THE NEW YORK CITY LANDMARKS PRESERVATION COMMISSION
1 CENTRE STREET 9TH FLOOR NORTH NEW YORK NY 10007
TEL: 212 669-7700 FAX: 212 669-7780

Re: **MISCELLANEOUS/AMENDMENTS**
LPC-23-02709
MISC-23-02709
53 WOOSTER STREET
SoHo-Cast Iron Historic District
MANHATTAN
Block/Lot: 475 / 17

Subsequently, on September 16, 2022, the Commission received a proposal for an amendment to the work approved under that permit. The proposed amendment consists of expanding the scope of work to include replacing an HVAC unit in-kind at the roof; and interior alterations at the cellar through third floors, as described and shown in a letter, dated September 9, 2022, and prepared by Matthew N. DeConzo, P.E.; and on drawings labeled M-001.01 through M-003.01, M-004.00, M-005.00, M-101.00, M-202.00, M-301.01, M-401.01, M-402.00, M-501.00, and M-601.00 through M-603.00, dated (revised) February 8, 2022, and prepared by Matthew N. DeConzo, P.E..

THIS PAA FILED TO SUBMIT AI-1 WITH REVISED DRAWING SET ILLUSTRATING MINOR PLAN CHANGES TO MS SCOPE OF WORK PROPOSED UNDER M00350247_P1.

DRAWING NUMBER: M-002.01

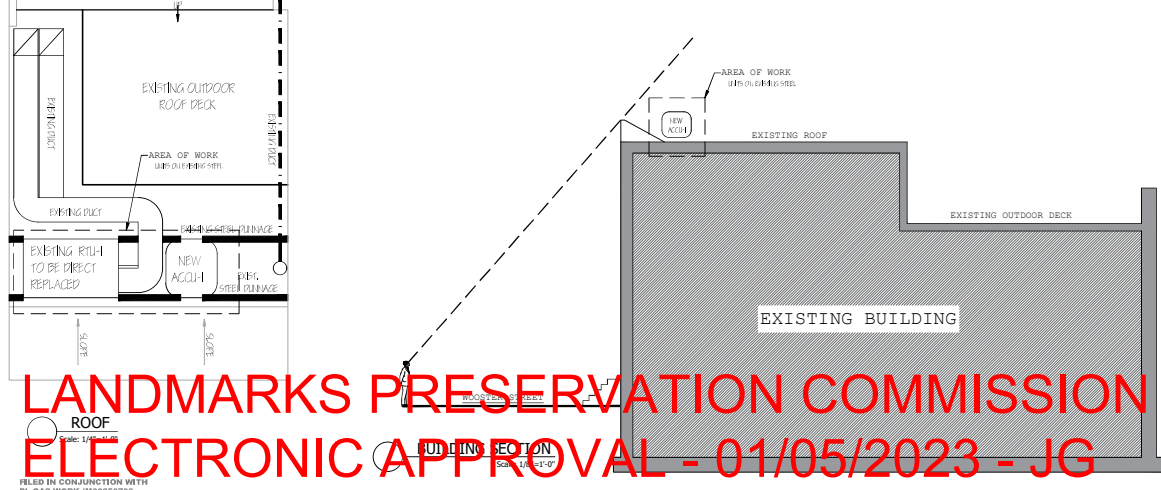
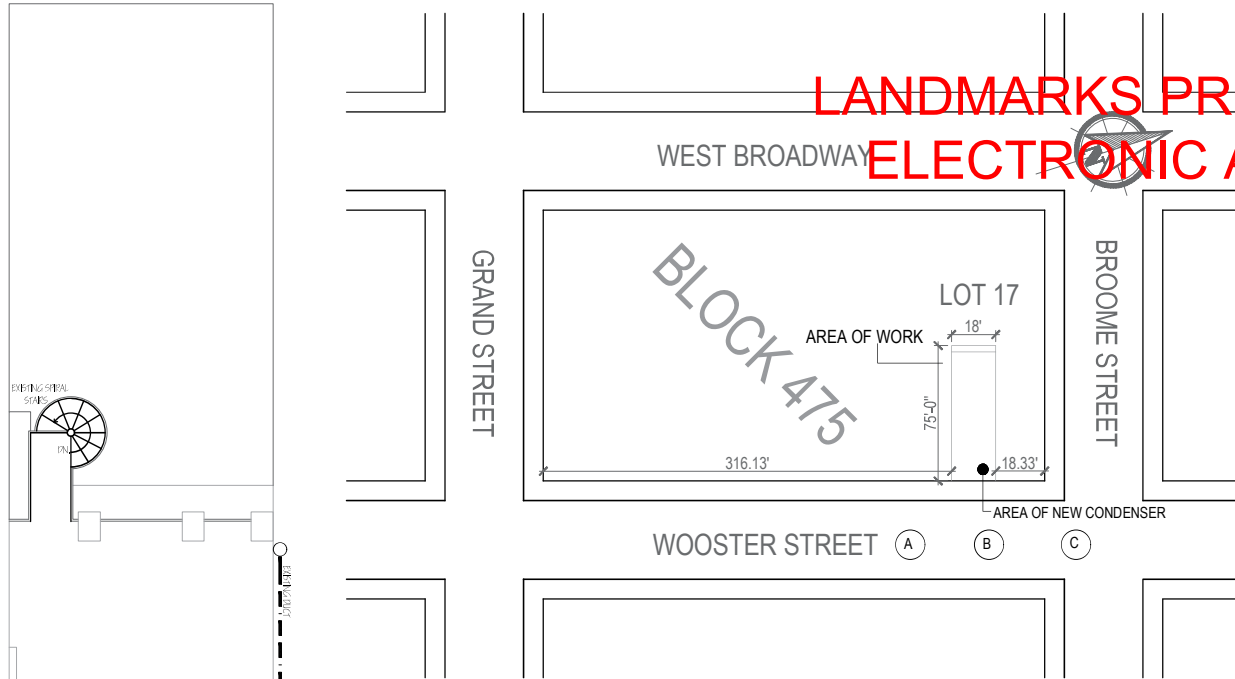
- M-001.01: Revised to update drawing list.
M-002.01: Revised to show direct replace hvac RTU location and sight line from street to roof.
M-003.01: Revised to add new color photos of proposed direct replace hvac RTU at roof.
M-004.00: No change Submitting sheet to retain integrity of complete set.
M-005.00: New sheet with mechanical compilation report.
M-101.01: Revised to update the roof plan to show direct replace RTU at roof to existing gas line.
M-202.00: New sheet showing the HVAC RTU model and spec information.
M-301.01: Revised to show updated riser, with direct replace gas fired HVAC RTU at roof
M-401.00: Revised to updated HVAC labels on diagrams.
M-402.00: No change Submitting sheet to retain integrity of complete set.
M-501.00: No change Submitting sheet to retain integrity of complete set.
M-601.00: No change Submitting sheet to retain integrity of complete set.
M-602.00: No change Submitting sheet to retain integrity of complete set.
